**From:** Devereaux, Sherri  
**Sent:** Thursday, October 01, 2015 2:29 PM  
**To:** Redfearn, Tyke  
**Cc:** Mattox, James H.; Bowers, Barry W; Schofield, Joseph R. (Joseph.Schofield@arcadis-us.com)  
**Subject:** FW: Questions from Design Build Teams- SC0319, SCDOT Project ID 0037345 - File 10.037345A, Design Build Charleston Port Access Road  
**Attachments:** Copper Yard PM.PDF; RE: Questions from Design Build Teams- SC0319, SCDOT Project ID 0037345 - File 10.037345A, Design Build Charleston Port Access Road

Design Build Teams are currently reviewing the RFP for the Charleston Port Access Project. There are a couple of questions on the Site 8 clearance information.

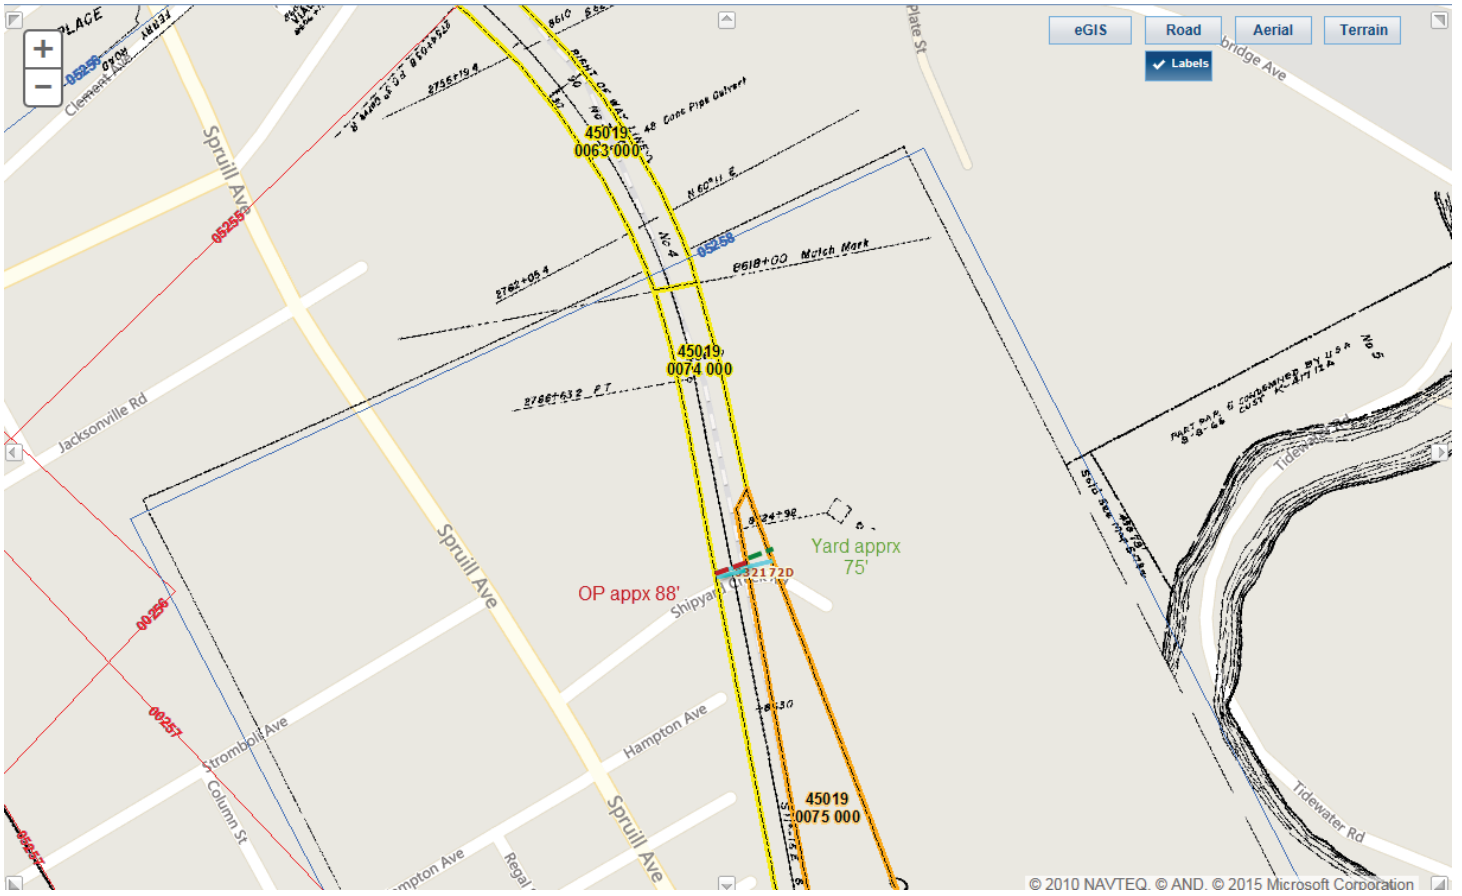
1. Can clarification as to the width of the CSXT operating corridor, depicted in yellow on the VAL map, be provided?

2. Does the minimum clearance requirement of 23' plus 1' above existing rail lines extend only six feet each side of the centerlines of the covered/partially covered tracks?

CSX's Response: **Site 8 north of Cooper Yard, assume 88-foot RR width in yellow plus 75-feet across the orange yard shape shown on the VAL map.** (see attachment)

CSX's Response: **yes, 6-feet from centerline of existing tracks, plus 1-foot** (see attached email)
